LENTOKELPOISUUSMÄÄRÄYS
AIRWORTHINESS DIRECTIVE

M 2573/98

Muutos 1

Maule. Siipitukien tarkastus.

Figure 1

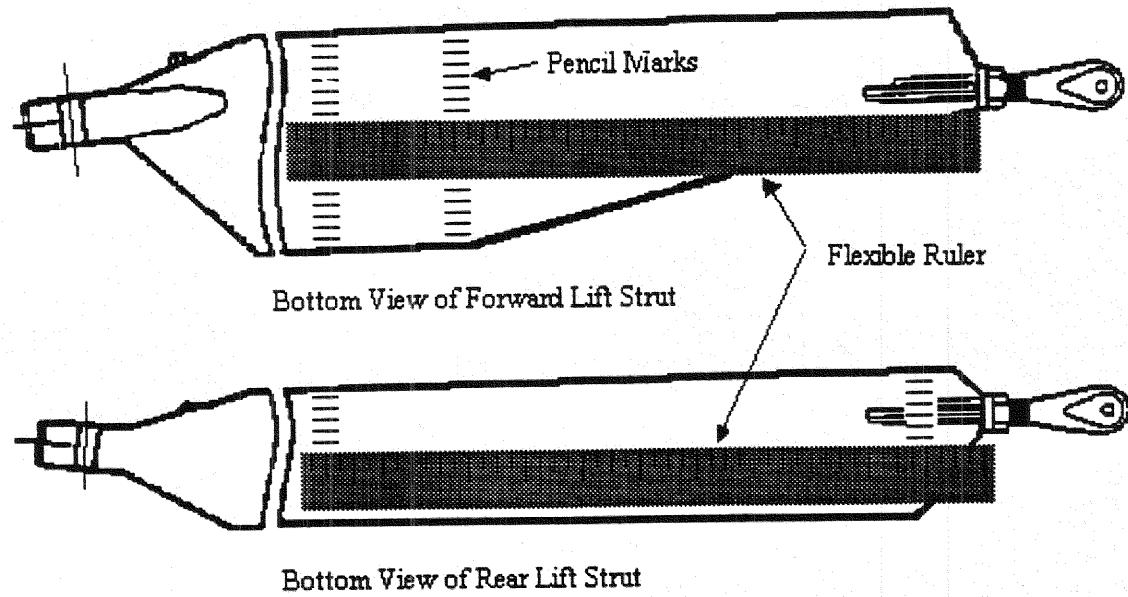
2. Using a flexible ruler, draw a 1/4-inch grid on the surface of the first 11 inches from the lower end of the strut as shown in Maule Service Bulletin No. 11, dated October 30, 1995, as applicable. This can be done using a soft (#2) pencil and should be done on both faces of the strut. As an alternative to drawing a complete grid, make two rows of marks spaced every 1/4 inch across the width of the strut. One row of marks should be about 11 inches from the lower end of the strut, and the second row should be several inches away where the strut starts to narrow. Lay the flexible ruler between respective tick marks of the two rows and use tape or a rubber band to keep the ruler in place. See Figure 1.
